Access Compliance Report

Public Rights-of-Way (Curb Ramps)

Intersection ID: 10942	Main Street: S I-77 EXIT 10B RA	Cross Street: N/A	Location: S
ADA ID: ED2BB128D568	Ramp Type: BlendTrans2	Initial Pass/Fail: Fail	Overall Compliance: No
Severity Score: 8.75			
Codes/Mitigation Info/Possible Solution		Field Measurements/Component Compliance

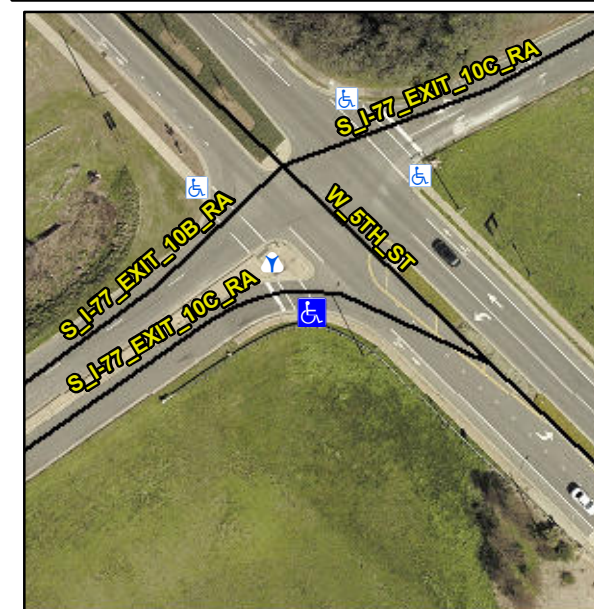
Not Found, R304.5.1

Compliance	Description	Data	Compliance	Description	Data
N/A	Ramp Length (in)	48.0	Yes	BlendTrans Slope (%)	2.3
No	Ramp Width (in)	47.5	Yes	BlendTrans XSlope (%)	1.0
N/A	Flare Type LT	N/A	N/A	Flare Type RT	N/A
N/A	Flare Slope LT (%)	N/A	N/A	Flare Slope RT (%)	N/A
N/A	Flare Traversable LT?	N/A	N/A	Flare Traversable RT?	N/A
N/A	Landing Length (in)	N/A	N/A	DWS Provided?	N/A
N/A	Landing Width (in)	N/A	N/A	DWS Contrast?	N/A
N/A	Landing Slope (%)	N/A	N/A	DWS Length (in)	N/A
N/A	Landing X Slope (%)	N/A	N/A	DWS Full Width?	N/A
N/A	Landing Curb? (Y/N)	N/A	N/A	DWS Offset (in)	N/A
N/A	Shared Landing?	N/A			
N/A	Gutter Ponding?	N/A	N/A	Gutter Slope (%)	N/A
N/A	Gutter Lip Ht (in)	N/A	N/A	Gutter X Slope (%)	N/A
N/A	Painted X Walk1?	No	N/A	Painted X Walk2?	Yes
	X Walk 1 Direction	To NE		X Walk 2 Direction	To NW
	X Walk 1 Width (in)	N/A		X Walk 2 Width (in)	112.0
	X Walk 1 Slope (%)	4.3		X Walk 2 Slope (%)	3.0
	X Walk 1 X Slope (%)	1.7		X Walk 2 X Slope (%)	3.0

N/A	Ramp inside XWalk1?	N/A	N/A	Ramp inside XWalk2?	Yes
	Road Slope (%)	0.9		Clear Space?	N/A
	Road X Slope (%)	4.2	N/A	Clear Space to XWalk (in)	N/A
N/A	Any Obstructions?	N/A	N/A	Storm Grate/Utility Hazard?	N/A
	Obstruction Type			Storm Grate/Utility Type	
		N/A			N/A
			Yes	Surface Condition? (G/P)	Good
			No	Curb Slope (%)	9.8

Remove & Replace Curb Ramp With Two New Directional Ramps or Equivalent.
